Indoor Station Firmware V2.2.2_build221129

Release Note (2022-12-02)

Device Model	DS-KH8350-WTE1, DS-KH8350-TE1, DS-KH6320-WTE1, DS-KH6320Y-WTE2, DS-KH6320-WTE2(B), DS-KH6320-TE1, DS-KH8520-WTE1
Firmware Version	V2.2.2_build221129
iVMS-4200	V3.8.3.1 or later

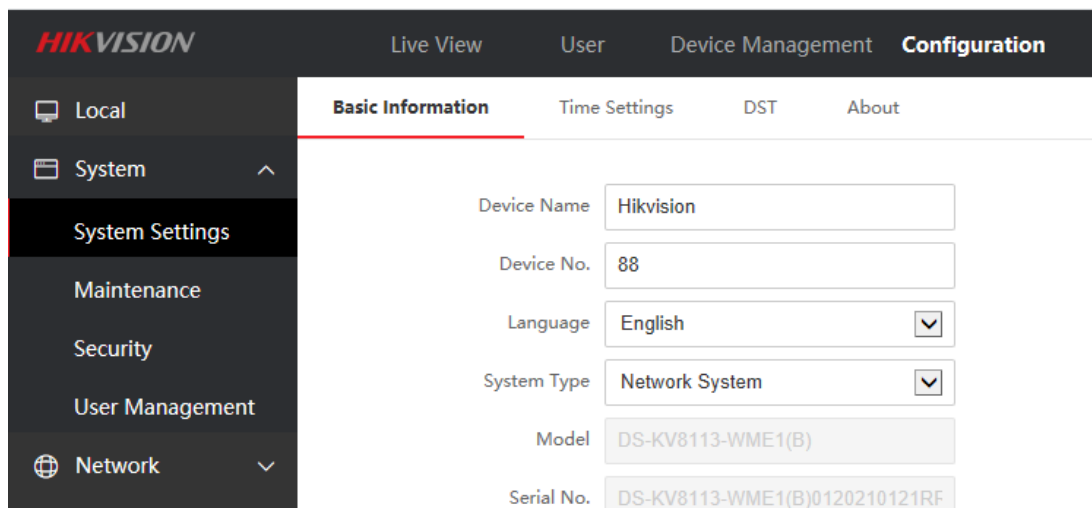
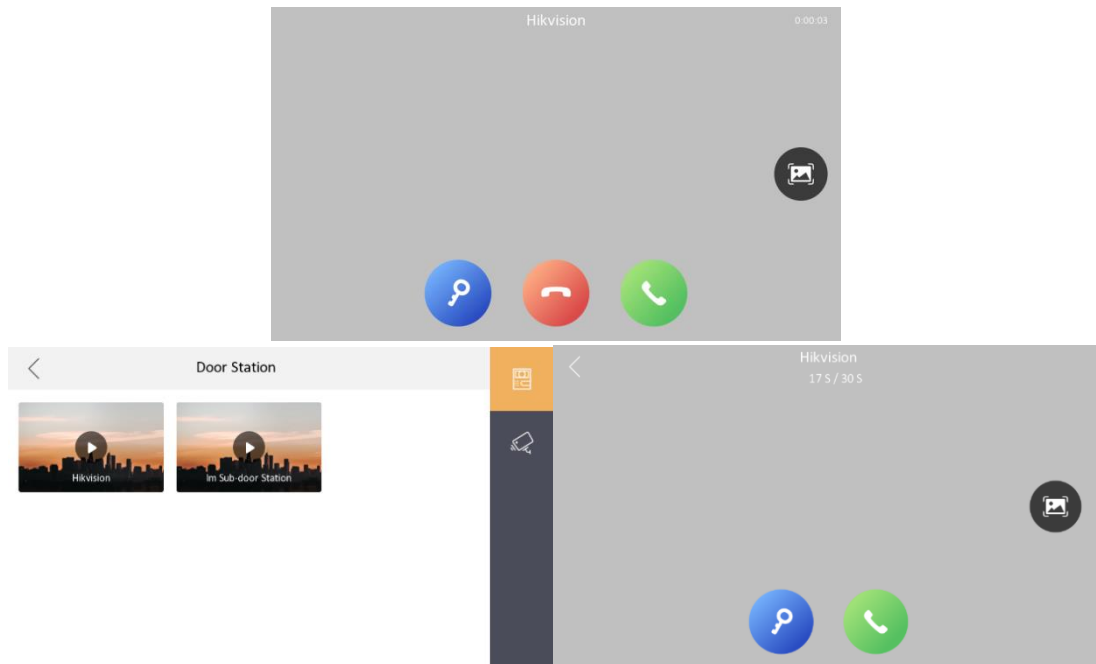
1. Change the position of unlock password and duress code, to enter the password page requires an admin (activation) password.

2. When changing the unlock password and duress code, the old password is not required as a credential.
3. The name of the local private SIP password configuration Sip Password is uniformly changed to Registration Password
4. The changed name of the door station(KD8003 modular door station, KV(-B), KB8113) will be displayed on the call interface or live view interface of the indoor station

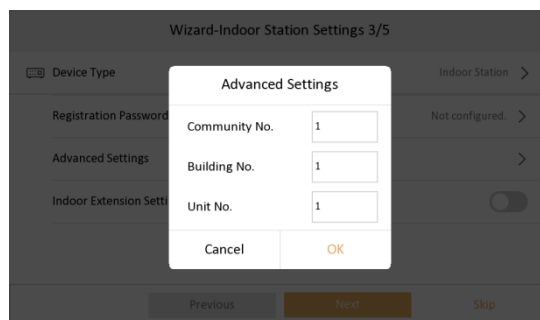
5. The local interface community number, building number, and unit number of the indoor station will be stored in the advance column instead of being displayed directly

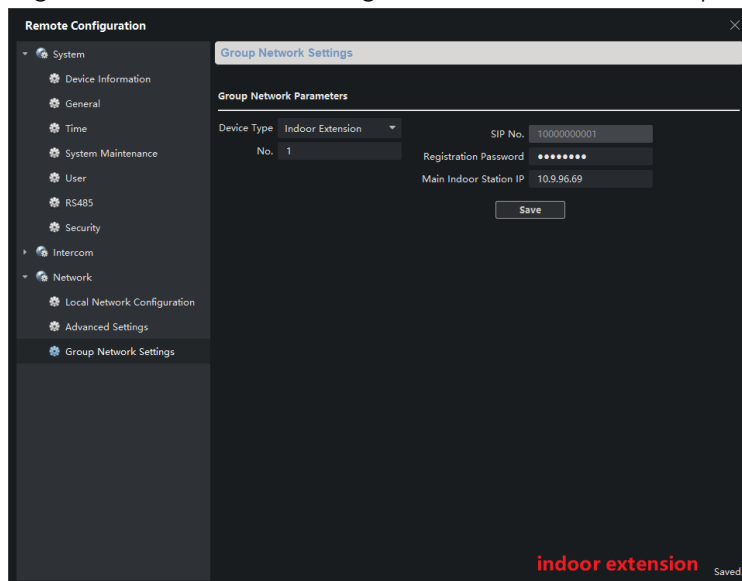
6. The method of adding indoor extensions is changed to the same method as protocol 1.0

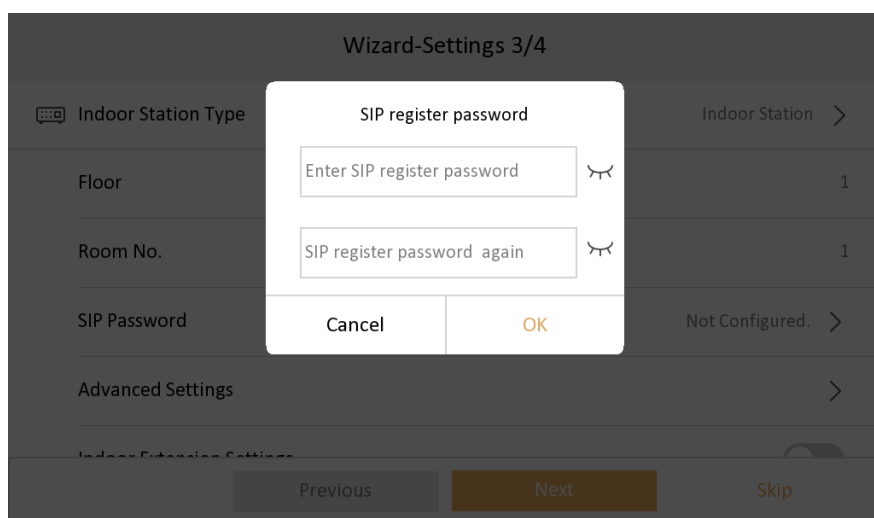
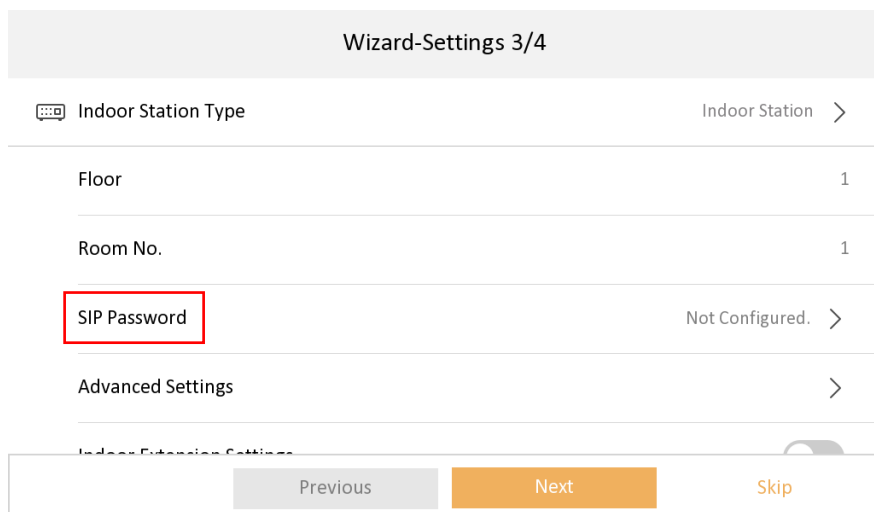
1. Higher security, SIP Passwords

SIP password is actually Register Password, which is suitable for our security 2.0 protocol. They can communicate normally only when the **SIP passwords (Register passwords)** of the door station, indoor station and indoor extension are the **same**.

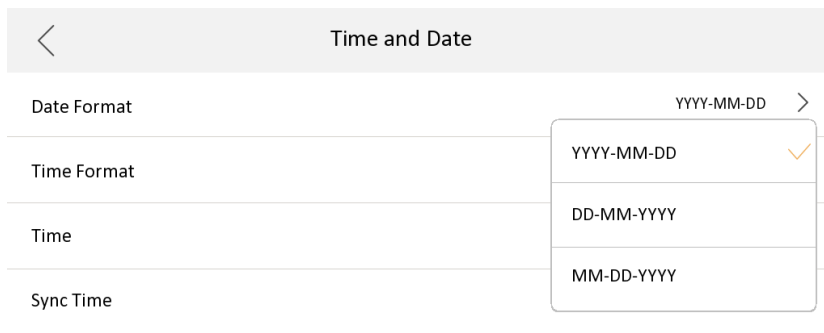
2. Support three date formats, two clock format configuration (Time format only allows local modification)

1) Support three formats in Settings->General Settings->Time and Date interface, set year-month-day, day-month-year, month- day - year

2) Support the Settings->General Settings->Time and Date interface, set the 12-hour system, 24-hour system two formats, and the default setting is 24-hour system display.

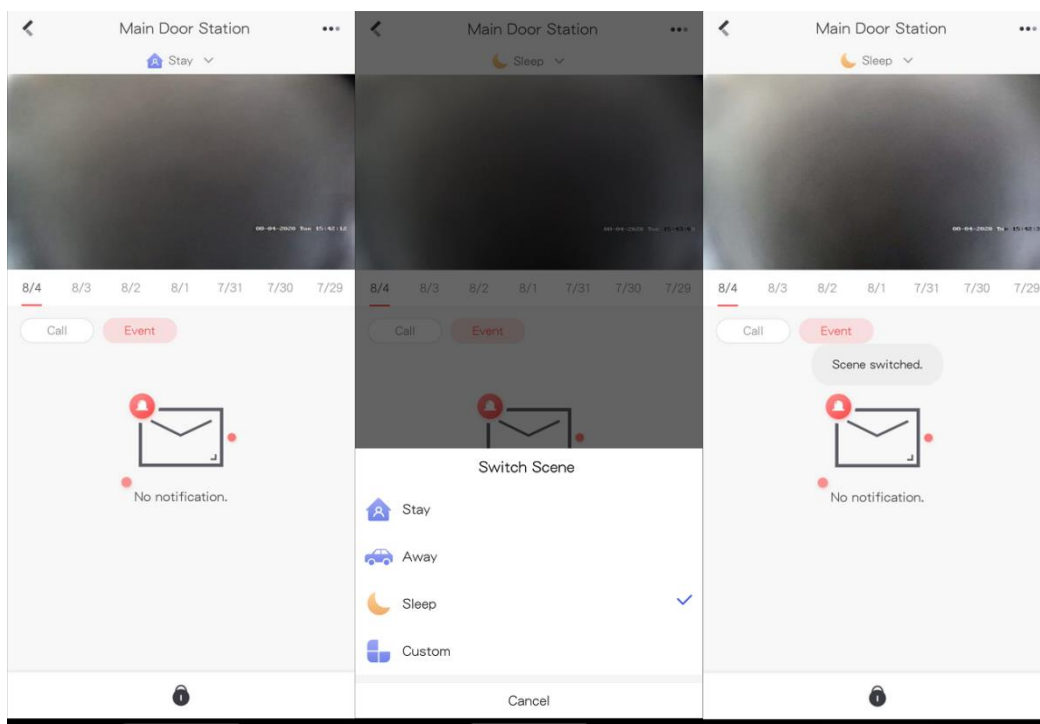
3. Multi-language added to 12 countries: English, French, Portuguese (Brazil), Spanish, Russian, German, Italian, Polish, Arabic, Turkish, Vietnamese, Ukrainian.

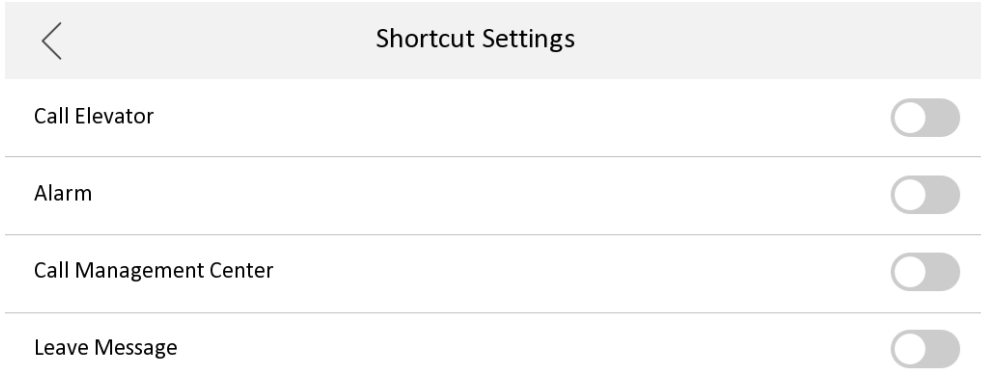
5. Support whether to enable the call management center function, it is disabled by default

6. Support whether to enable the leave message function, it is disabled by default

1) In the Settings->More->Preference->Shortcut Settings interface

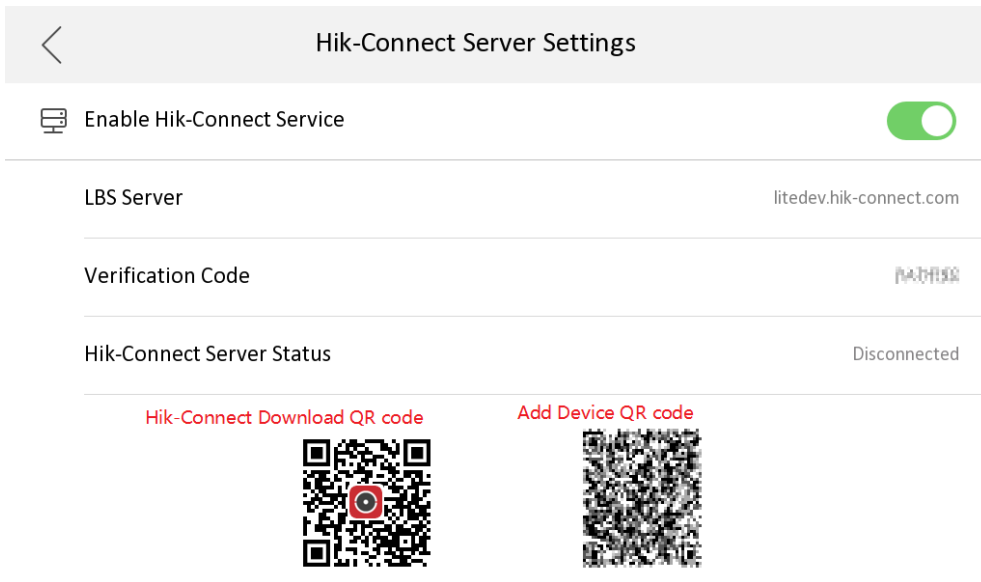
7. Add the QR code of Hik-Connect App download address to the indoor station Hik-Connect configuration interface

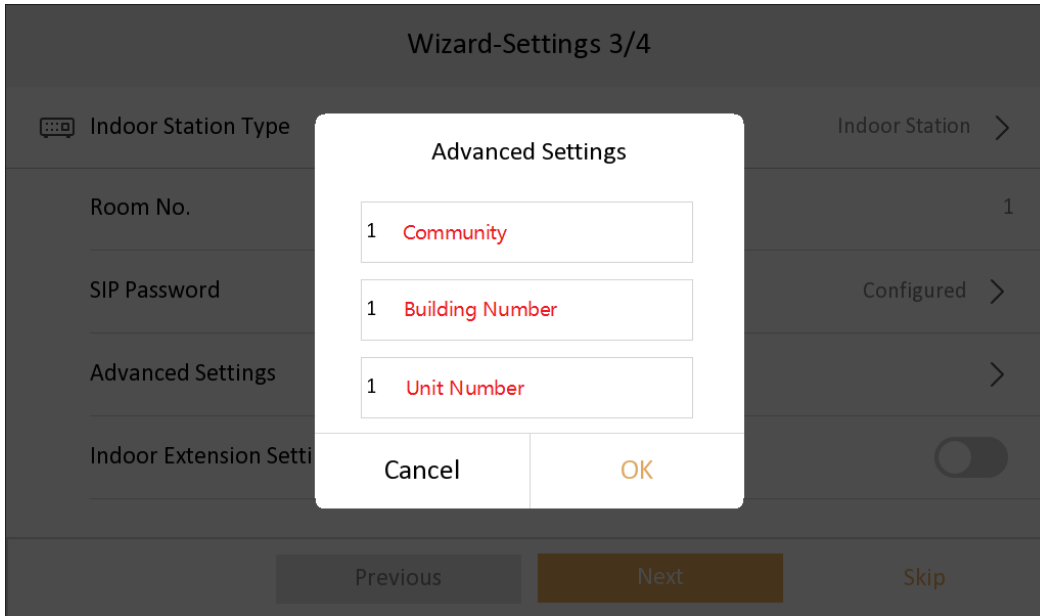
- 1) Support setting period number, building number, and room number on the indoor station;

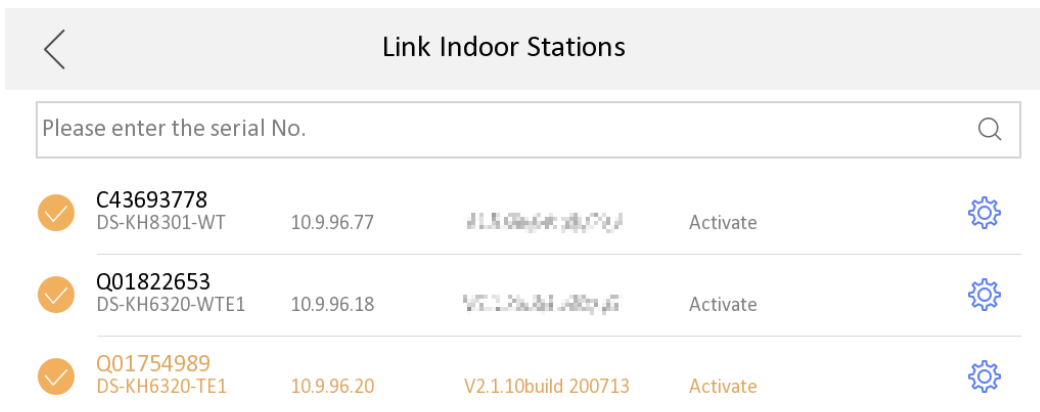
- 2) Support remote configuration of indoor extension information through the main indoor station;

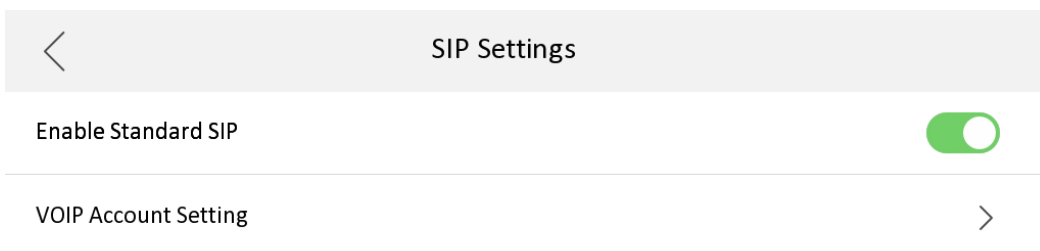
- b) The standard SIP of the indoor station is disabled by default, if you want to connect to a third-party standard SIP device, you need to turn on this function.

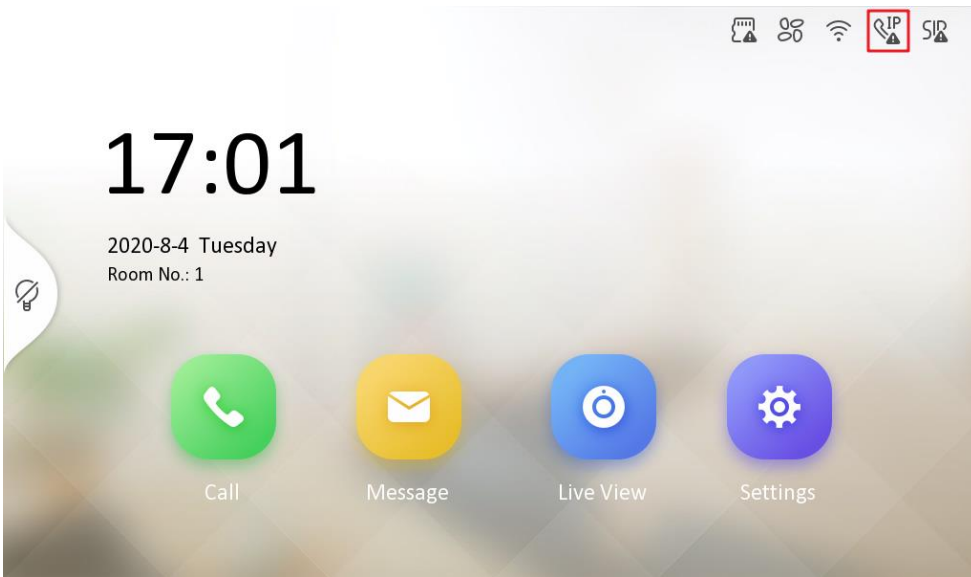
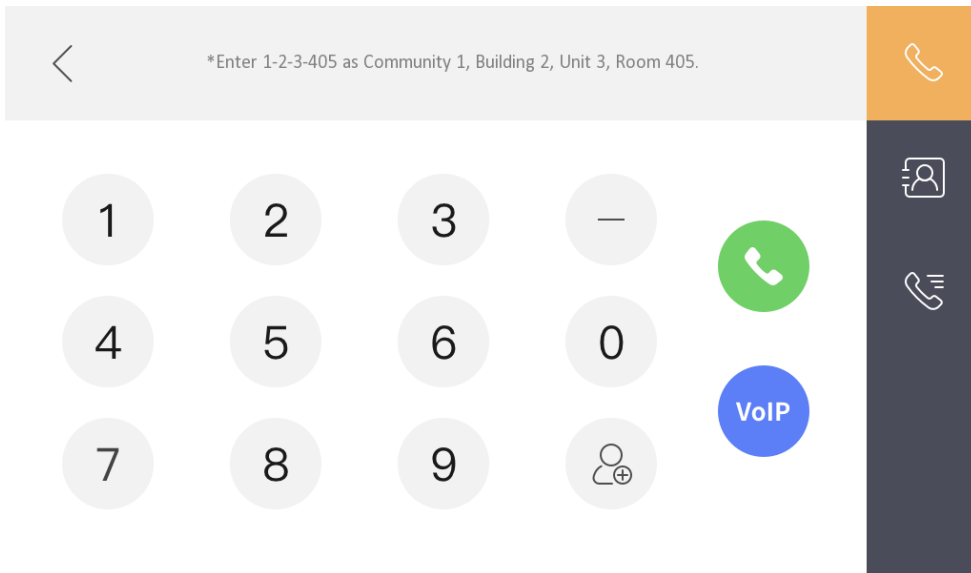
- c) A standard SIP registration status icon is added to the main interface, which can be displayed/hidden

according to whether standard SIP is enabled;

d) Added a VoIP call button in the call interface to distinguish standard SIP calls
